Making sense of Annex 178B

- There has been mixed views on what is ILT, path start-up, etc., as defined in Annex 178B in Draft 2.1

Proposed revisions to Annex 178B

Figure 178B–1—ISL and Path

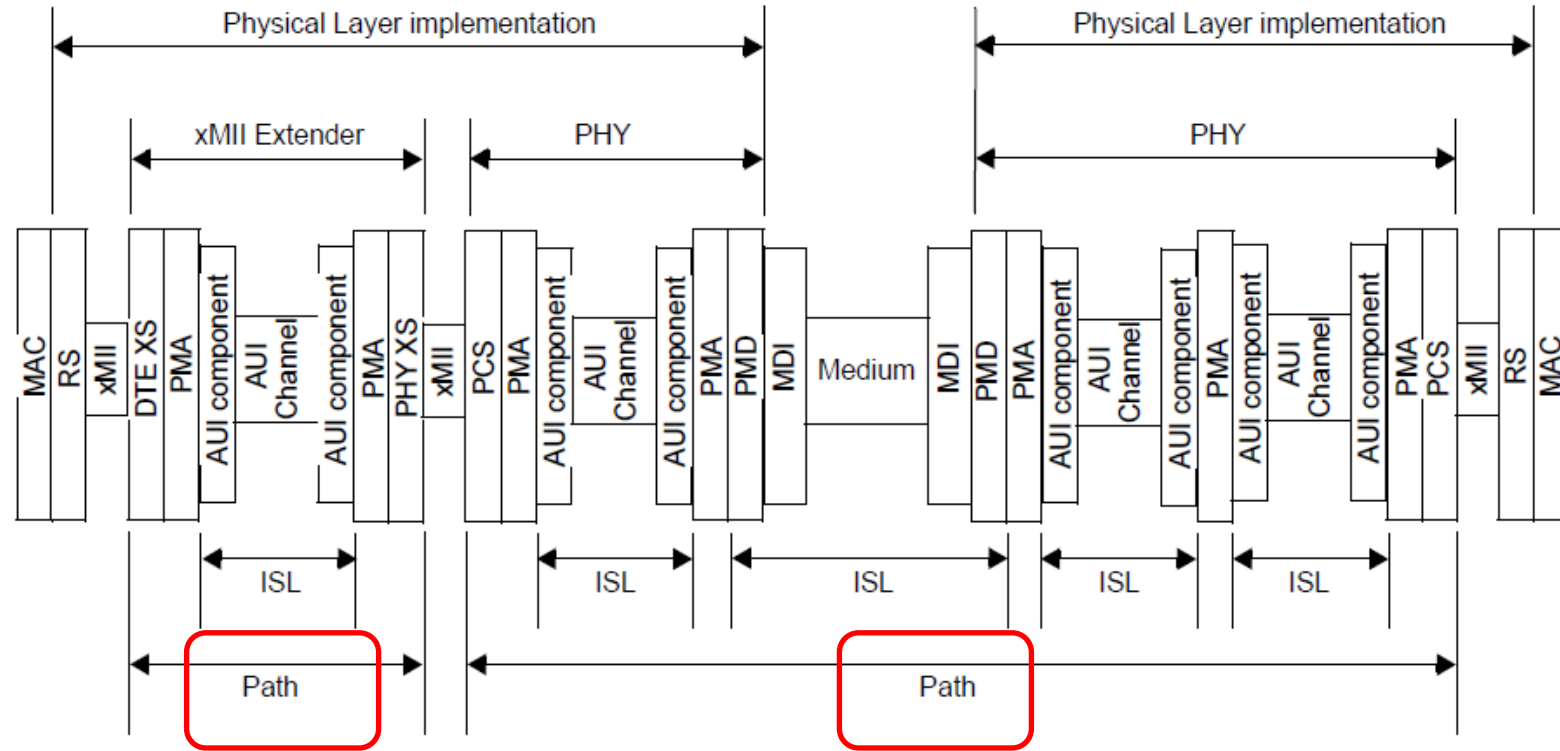
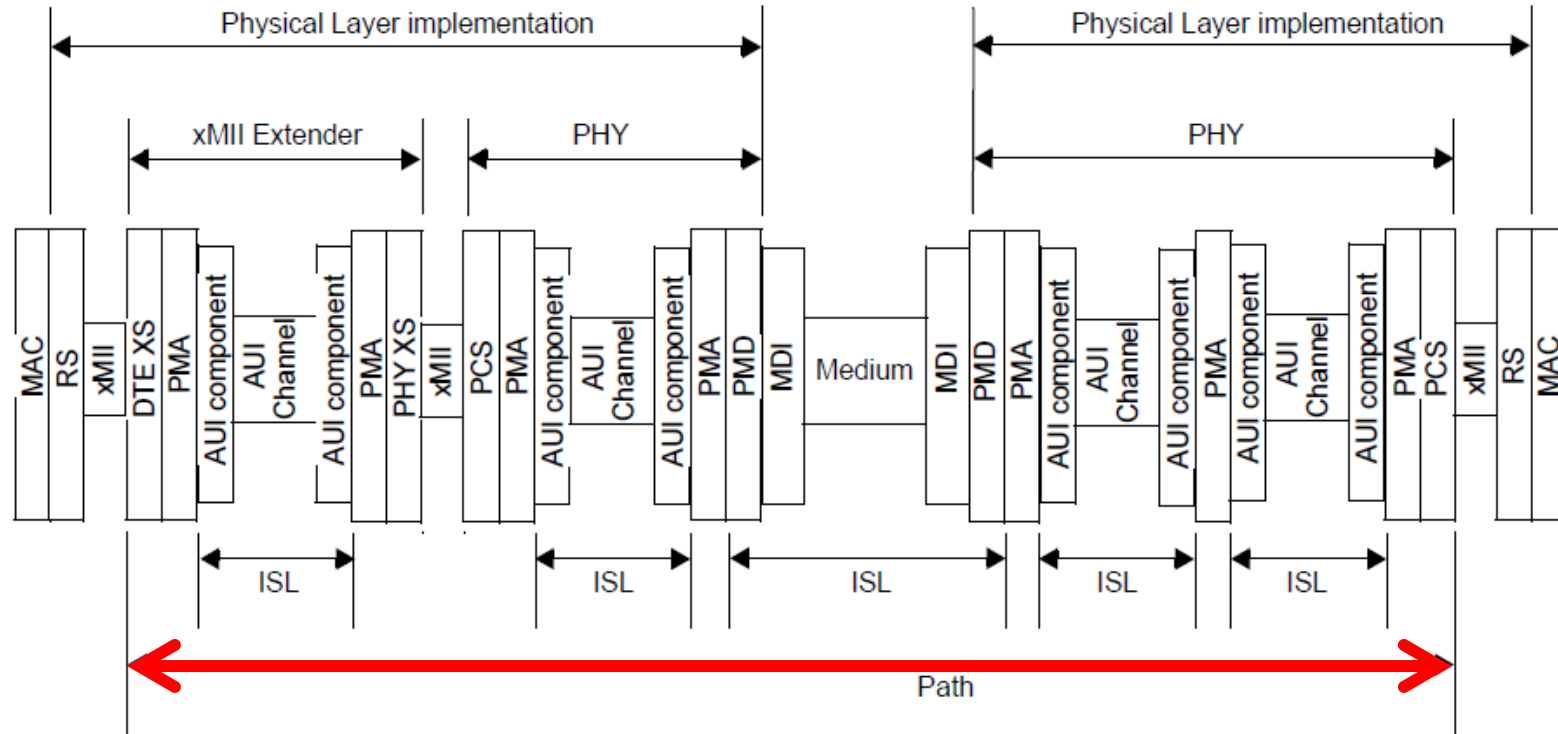
The series of ISLs and sublayers between a pair of PCS sublayers or a pair of Extender Sublayers. See Figure 178B–1.

Intended “Path” in Annex 178B is RS to RS

Although this is effectively the same as the general definition in 1.4.455, it might be helpful to rephrase it in the context of ILT and path start-up:

Path -- The sequence of ISLs and intermediate sublayers providing the connectivity between two Reconciliation Sublayers. See Figure 178B-1.

Figure 178B-2—ILT function in AU1 components and PMDs

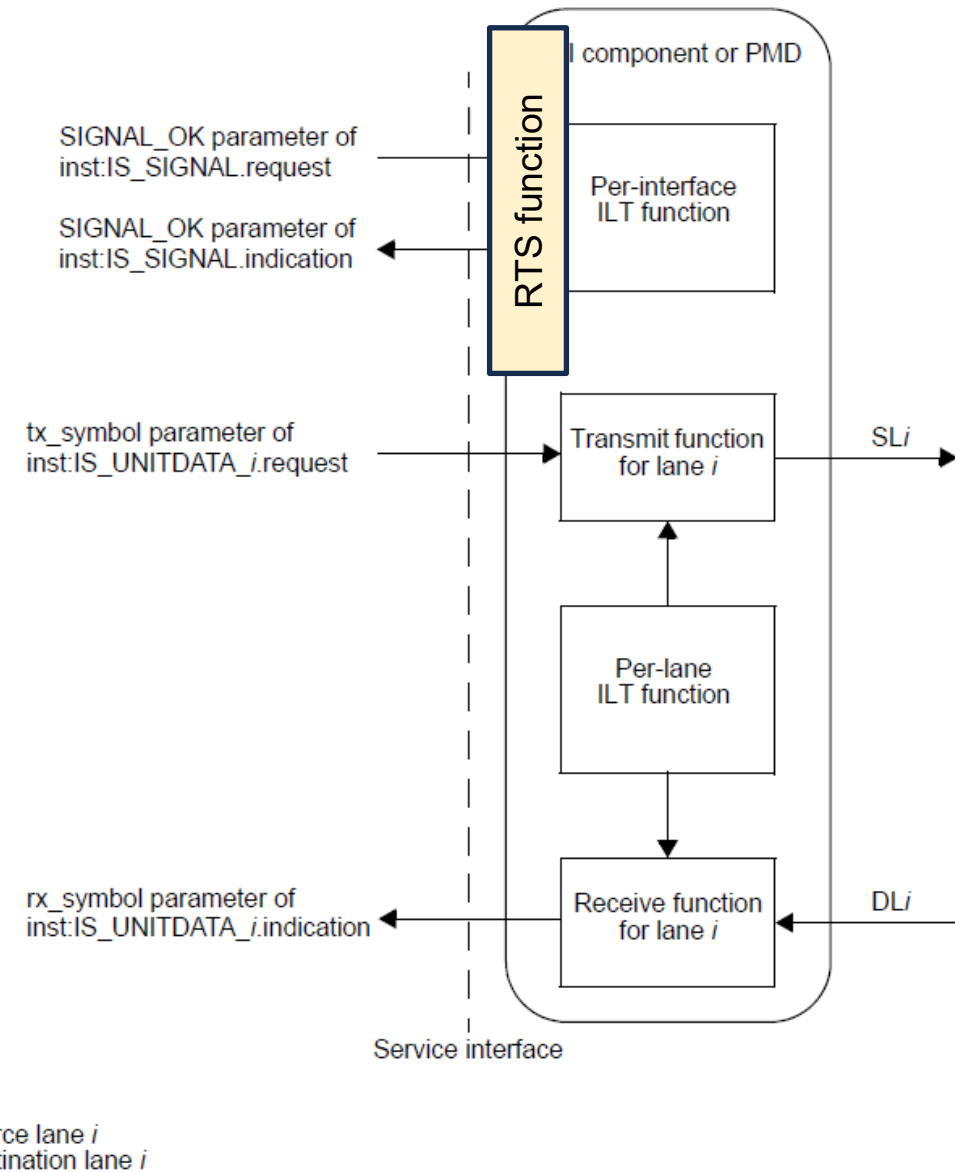
Figure 178B-2 would need to be updated to show:

- input SIGNAL_OK parameter is processed by the RTS function
- coordinates transmitter clock and data cutover
- the RTS status bit in the training frame is controlled by the RTS function

Update to the right is an approximate illustration.
